**Reference: Appleton Shores
Response to Mississippi Valley Conservation Authority Comments
Our File No.: 114165**

The following is in response to the Mississippi Valley Conservation Authority (MVCA) letters dated April 2nd, 2024 and April 29th, 2024.

MVCA TECHNICAL REVIEW MEMORANDUM dated April 2, 2024

CROSS-SECTION 1-1
STORMWATER MANAGEMENT FACILITY C1
SCALE 1:100

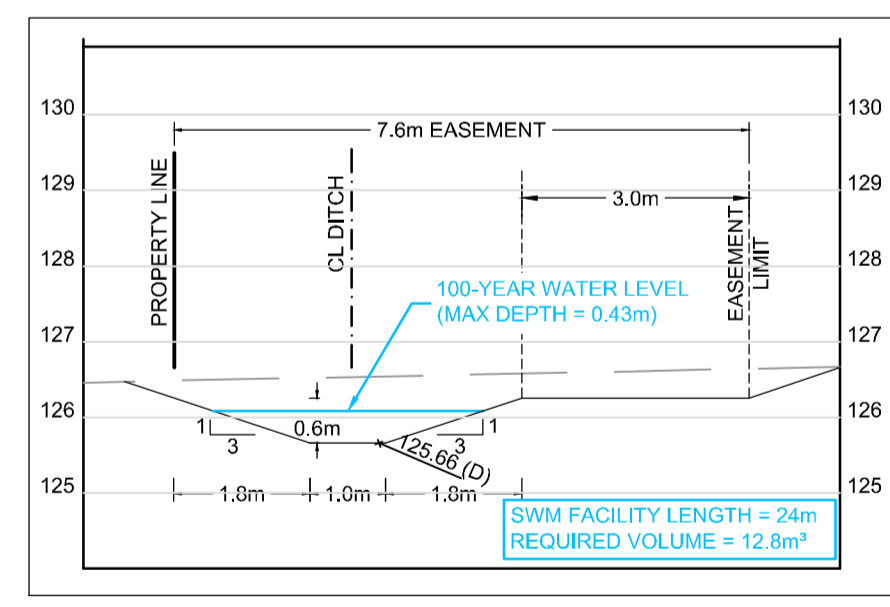
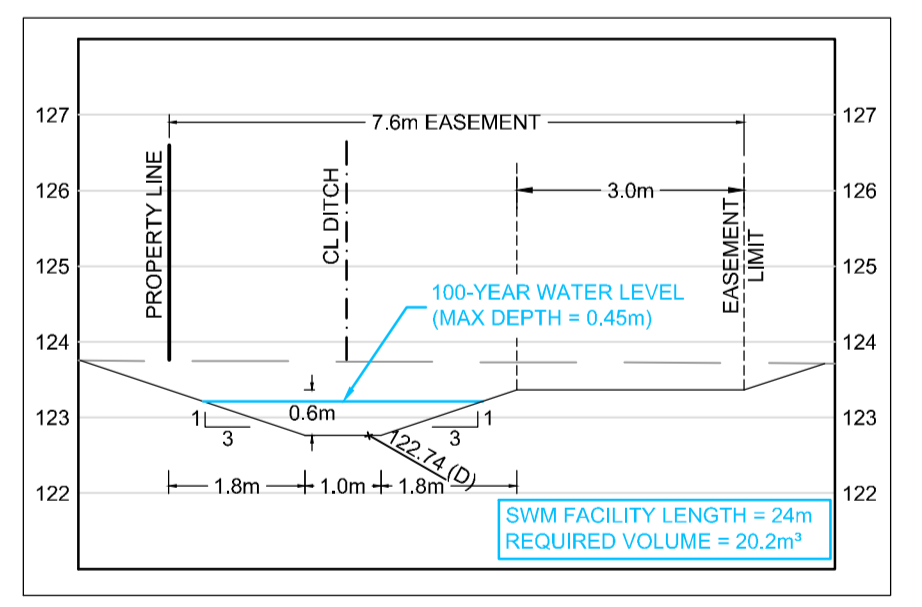
MVCA Comment 2: However it is recommended that concept level calculations and designs are completed prior to detailed design to demonstrate that the proposed outlet swales and roadside ditches have sufficient capacity to convey design storms (including the 100-year +20% storm “stress-test”) within the area allocated to these features. For example, what are the preliminary dimensions of the proposed linear stormwater management facility, and will it fit within the proposed drainage/stormwater management easement? The “stress-test” flows should be included in this analysis as well to confirm that no changes will need to be made to the layout during the detailed design phase.

Response: The roadside ditches and the linear stormwater facilities have been designed and Novatech modelled to contain and convey the 100-year storm events. Further details have been provided on the Preliminary Grading Plan (114165-PGR, attached) including cross-sections showing the modelled 100-year water levels from the Conceptual Stormwater Management Report (Novatech R-2022-139, Sept 2, 2022). At detailed design, the terrace elevations at the houses would be set above the “stress-test” elevations.

MUNICIPALITY of MISSISSIPPI MILLS	
APPLETON SHORES	
DRAWING NAME	PROJECT No.
CONCEPT PLAN - 14 Lots	114165-00
	REV
DRAWING No.	REV 08
114165-CP2021

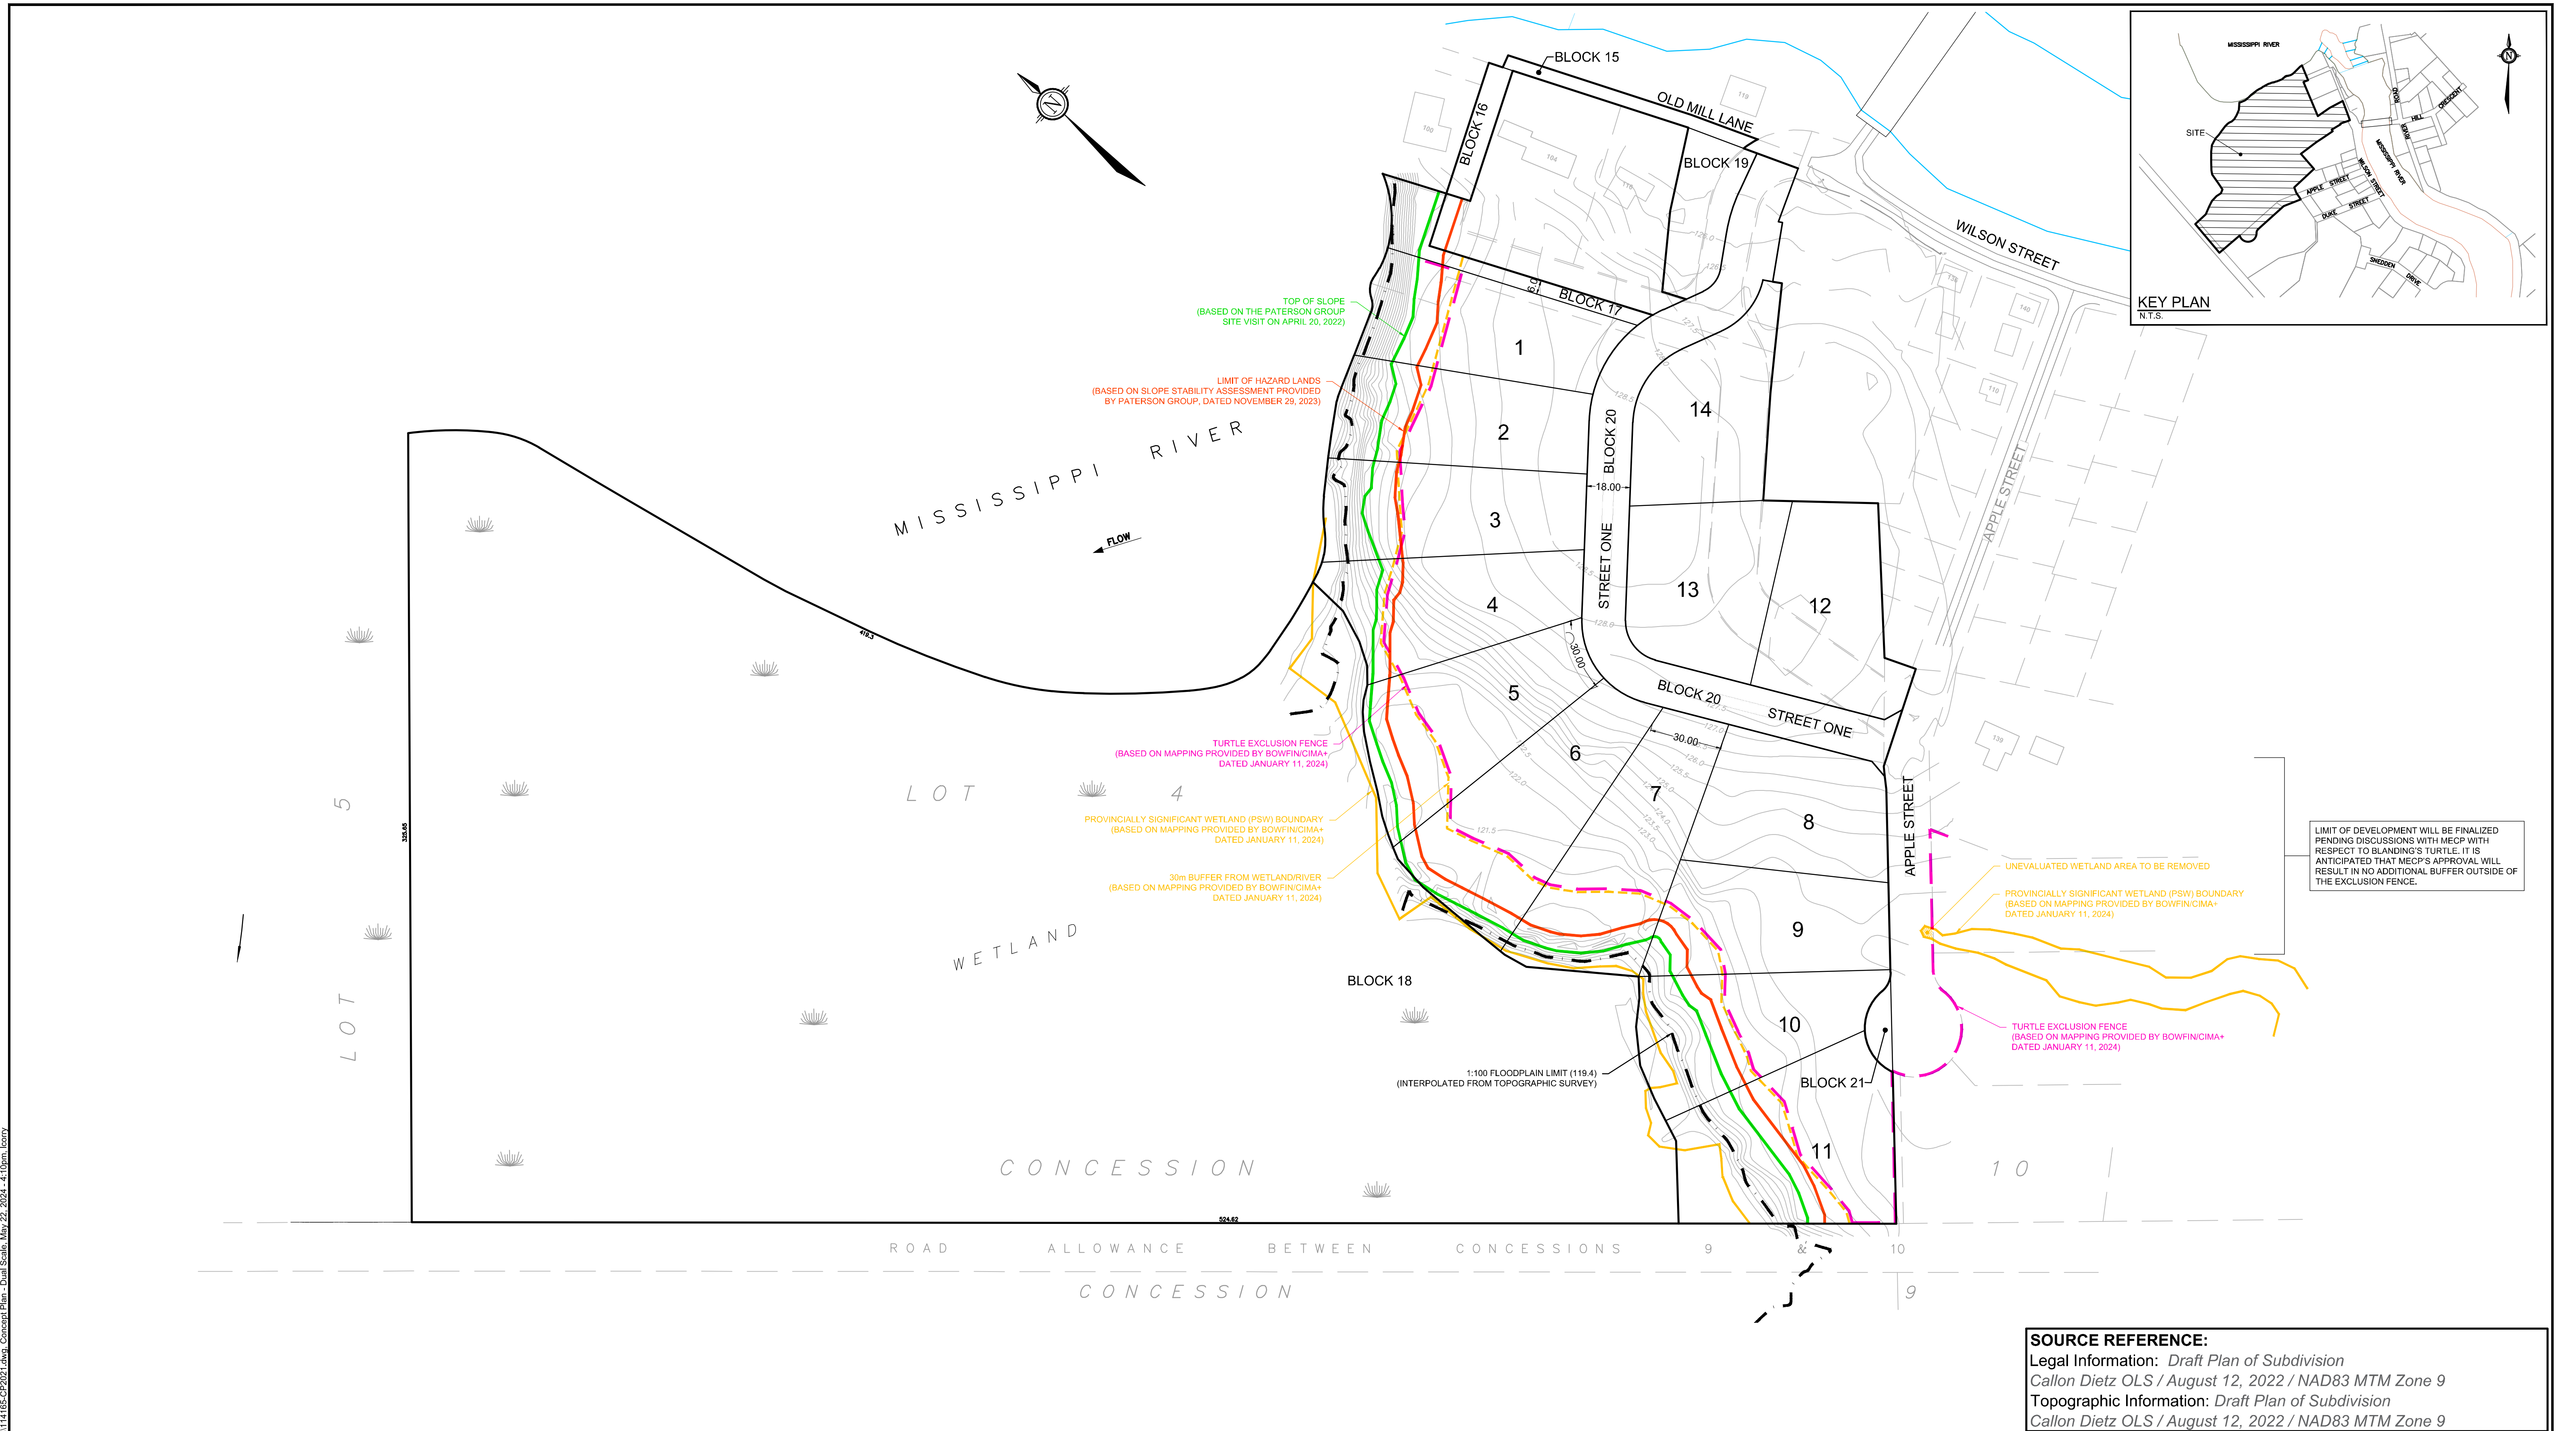
MVCA Comment: While MVCA does not have any further concerns with respect to Slope Stability, we request the addition of the revised Limit of Hazard lands on the final Constraints Plan.

MVCA Comment 1: Please ensure the updated [hazard] line is included on drawings in the detailed design phase.

Novatech Response: The revised Limit of Hazard Lands setback line has been added to the Concept Plan (114165-CP2021, attached).

Novatech Response: The revised Limit of Hazard Lands setback line has been added to the Concept Plan (114165-CP2021, attached).
